**[Docket No. FAA-2017-0288; Product Identifier 2017-CE-007-AD; Amendment 39-19231; AD 2018-06-11]**

#### **Airworthiness Directives; Textron Aviation Inc. Airplanes**

**ACTION:** Final rule.

Figure 1 to paragraphs (k)(1)(iii) and (v) of this AD: Cross section of v-band coupling

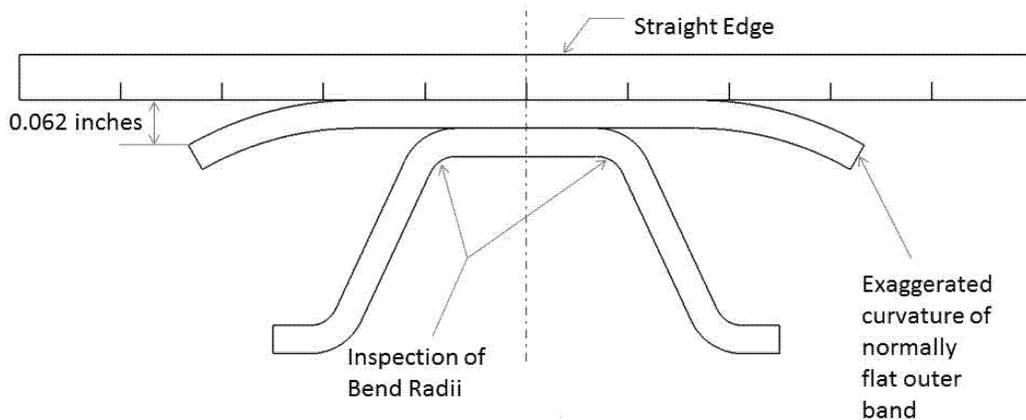
(iii) Visually inspect the flatness of the outer band using a straight edge. Lay the straight edge across the width of the outer band. The gap must be less than 0.062 inches. See figure 1 to paragraphs (k)(1)(iii) and (v) of this AD. If the gap exceeds 0.062 inches between the outer band and the straight edge, do not re-install the v-band coupling. Before further flight, you must install a new v-band coupling and restart the hours TIS for the repetitive replacement of the v-band coupling.

(v) Visually inspect the bend radii of the coupling v-retainer coupling segments for cracks. Inspect the radii throughout the length of the segment. See figure 1 to paragraphs (k)(1)(iii) and (v) of this AD. If any cracks are found, do not re-install the v-band coupling. Before further flight, you must install a new v-band coupling and restart the hours TIS for the repetitive replacement of the v-band coupling.
